# ERL Comment Proposal Overview (r02-19 - r02-26)

Richard Mellitz, Samtec

IEEE 802.3 50 Gb/s, 100 Gb/s, and 200 Gb/s Ethernet Task Force

# ERL limit of 12 dB is suggested by experiment

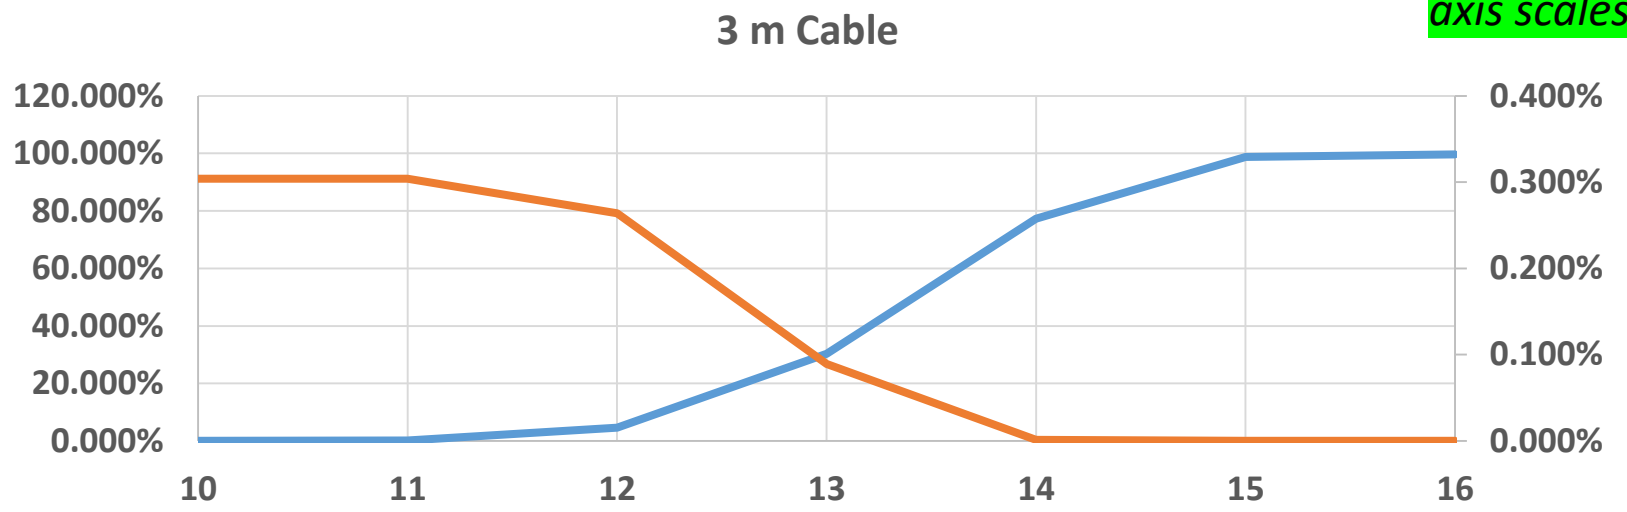
- ❑ Representing a wide range of design and manufacturing permutations
- ❑ Wide range of packages
  - 12 mm to 120 mm
  - Die pad capacitance up to 300 fF
  - Package differential impedance between 85 and 120 ohms
- ❑ Wide range of board and intra-cable configurations
  - Up to 70 mm of host trace with up to 500 mm of cable
  - Board impedance between 80 and 100 ohms
- ❑ QSFP connectors and mounting
- ❑ 2 DAC cables
  - 3 meter cable which just barely passes COM
  - 2 meter cable fabricated with reflections and barely passes COM
    - 270 fF added to QSFP assembly

# Suggest Tx host ERL minimum 12 dB

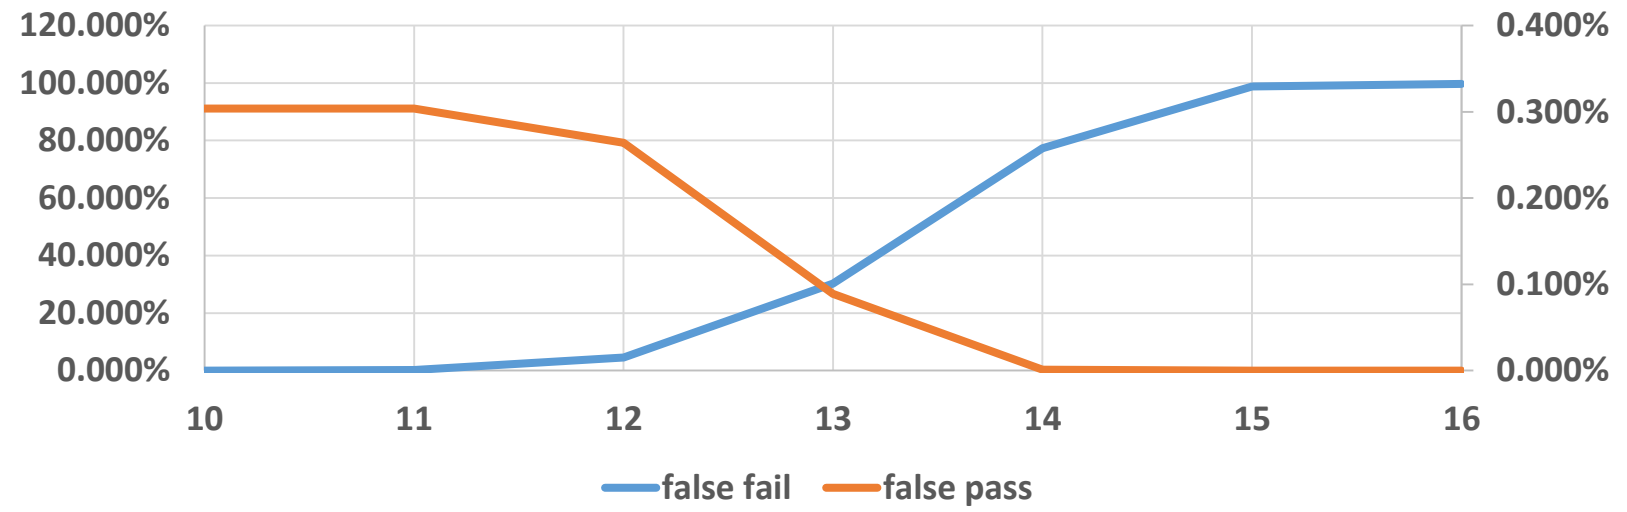
3 m cable		
ERL	false fail	false pass
10	0.001%	0.304%
11	0.175%	0.304%
12	4.569%	0.264%
13	30.265%	0.089%
14	77.336%	0.001%
15	98.754%	0.000%
16	99.696%	0.000%

2 m reflective cable		
ERL	false fail	false pass
10	0.000%	0.035%
11	0.174%	0.034%
12	4.592%	0.001%
13	30.446%	0.000%
14	77.605%	0.000%
15	99.023%	0.000%
16	99.965%	0.000%

# Plotting on same scale could suggest ERL min could be more like 10 dB or 11 dB

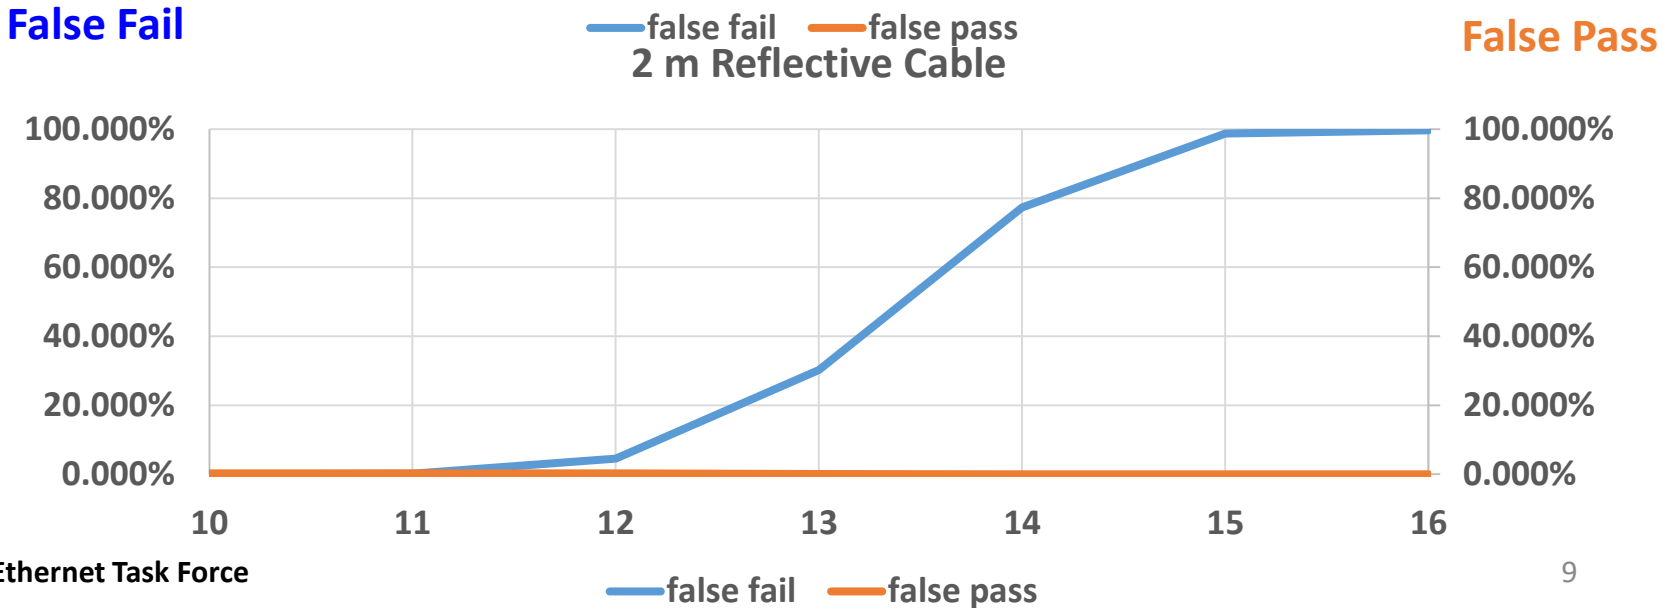
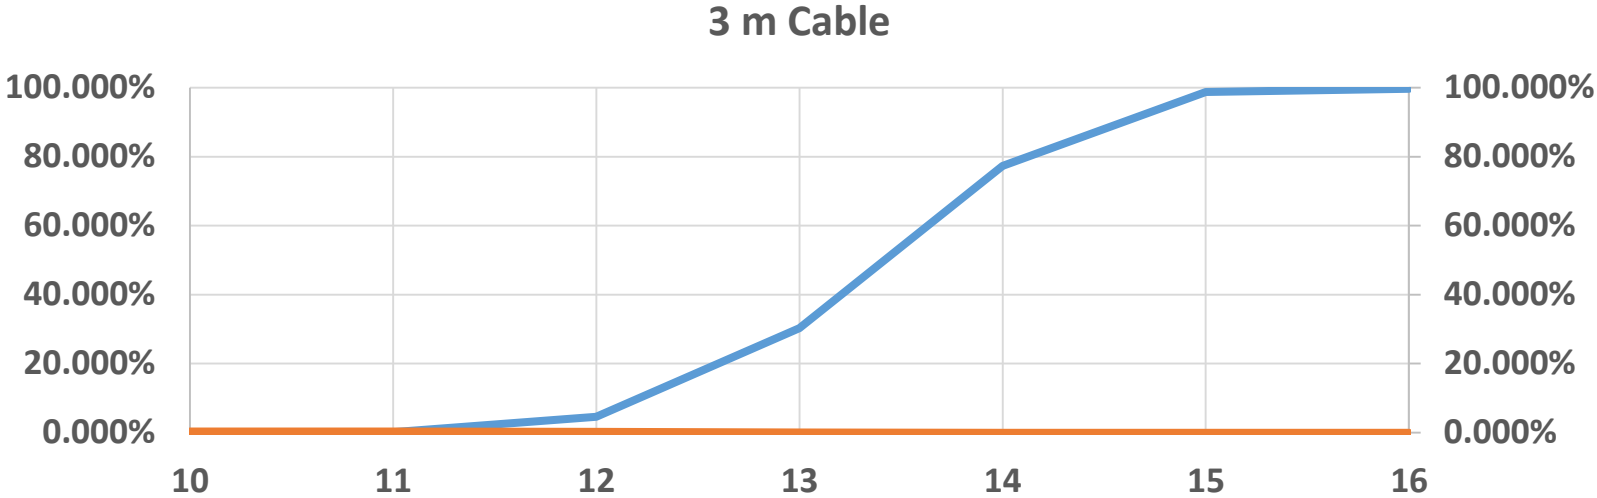
3 m cable		
ERL	false fail	false pass
10	0.001%	0.304%
11	0.175%	0.304%
12	4.569%	0.264%
13	30.265%	0.089%
14	77.336%	0.001%
15	98.754%	0.000%
16	99.696%	0.000%

2 m reflective cable		
ERL	false fail	false pass
10	0.000%	0.035%
11	0.174%	0.034%
12	4.592%	0.001%
13	30.446%	0.000%
14	77.605%	0.000%
15	99.023%	0.000%
16	99.965%	0.000%
